N1922A-01

S E R V I C E N O T E

Agilent P-Series Wideband Power Sensors

Loose bulkhead (N1920-60005)

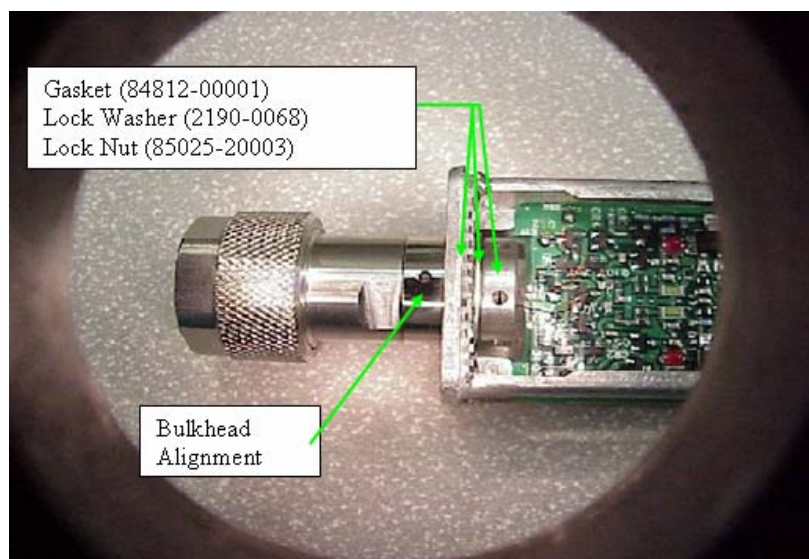
Loose bulkhead (p/n: N1920-60005) for P-series wideband power sensor built in US. Kindly send it to local service center for rework.

1. Screw lock nut 85025-20003 onto threaded end of bulkhead assembly. Apply loctite (0427-0231) on the first, second and third threads of the end of the bulkhead (as shown in the figure below):

2. Torque lock nut to 28 in. -lbs. with T-314592.
